### **REMARKS/ARGUMENTS**

The attached sheet of drawings includes changes to Fig. 2A. This sheet, which includes Fig. 1 and Fig. 2A, replaces the original sheet including Fig. 1 and Fig. 2A. In Fig. 2A, the centrifugal fan 205 has been amended to show its approximate profile in the clean bench 200.

CLEAN BENCH  
Application No. 10/621,391  
Inventor: CHANG, Ta-Kuang et al.  
*Annotated Sheet Showing Changes*

FIG.2A

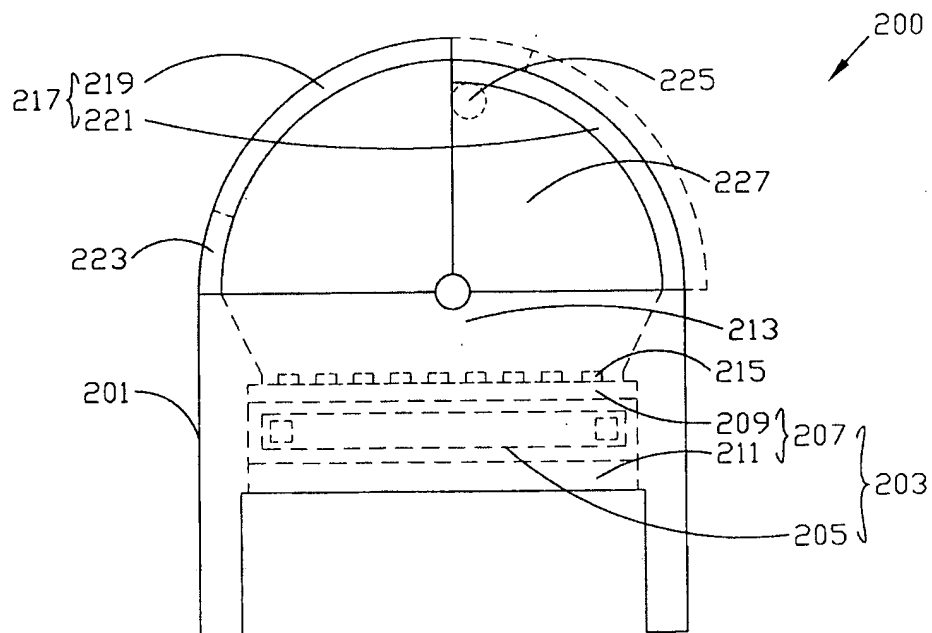
In amended Figure 2A, the centrifugal fan 205 has been amended to show its approximate profile in the clean bench 200.
